## Errata: CS43L42 Revision G

CS43L42 Low Voltage, Stereo DAC with Headphone Amp

Figure 1. Optional Headphone Mute Circuit for Revision G

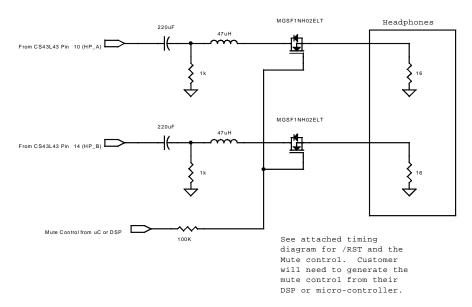
- For critical applications, the PopGuard<sup>©</sup> Transient Control may not be sufficient in eliminating extraneous audible artifacts on the headphone outputs during power-up. For these applications, an optional external mute can be used to maintain an absolute minimum of extraneous clicks and pops. Please see Figures 1 and 2 for the headphone mute circuit. For the line outputs, please use the optional mute circuit shown in the CDB43L42 schematic.
- The headphone outputs clip when the value of VA\_HP is below VA. It is recommended that these two supplies be tied together.
- When the Analog Headphone Attenuation Control registers (02h and 03h) are set for attenuation levels greater than -10 dB, the actual attenuation deviates from the register setting by more than 1 dB.

The Motorola MOSFETs shown have been tested to work properly, however, an equivalent device may be used.
